# Access Compliance Report

## Public Rights-of-Way (Curb Ramps)

Intersection ID: 12089	Main Street: E_12TH_ST	Cross Street: N_DAVIDSON_ST	Location: W
ADA ID: 6D5ED037D793	Ramp Type: Directional1	Initial Pass/Fail: Fail	Overall Compliance: No
		Severity Score: 12.5

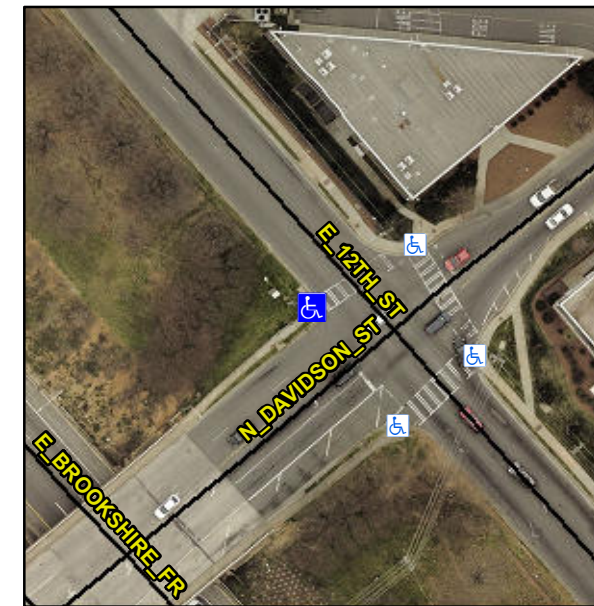
Compliance	Description	Data	Compliance	Description	Data
N/A	Ramp Length (in)	71.0	N/A	Grade Break?	N/A
Yes	Ramp Width (in)	60.0	N/A	Grade Break Slope (%)	0.0
Yes	Ramp Slope (%)	5.6	N/A	Grade Break XSlope (%)	0.0
No	Ramp XSlope (%)	6.7			
N/A	Flare Type LT	N/A	N/A	Flare Type RT	N/A
N/A	Flare Slope LT (%)	N/A	N/A	Flare Slope RT (%)	0.0
N/A	Flare Traversable LT?	N/A	N/A	Flare Traversable RT?	N/A
N/A	Landing Length (in)	0.0	N/A	DWS Provided?	N/A
N/A	Landing Width (in)	0.0	N/A	DWS Contrast?	N/A
N/A	Landing Slope (%)	0.0	N/A	DWS Length (in)	N/A
N/A	Landing X Slope (%)	0.0	N/A	DWS Full Width?	N/A
N/A	Landing Curb? (Y/N)	N/A	N/A	DWS Offset LT (in)	N/A
N/A	Shared Landing?	N/A	N/A	DWS Offset RT (in)	N/A
N/A	Gutter Ponding?	0.0	N/A	Gutter Slope (%)	N/A
N/A	Gutter Lip Ht (in)	0.0	N/A	Gutter X Slope (%)	N/A
N/A	Painted X Walk1?	Yes		Road Slope (%)	3.8
	X Walk 1 Direction	To NE		Road X Slope (%)	5.5
	X Walk 1 Width (in)	104.0		Clear Space?	N/A

**Remove & Replace Entire Ramp.**

**R304.5.3**
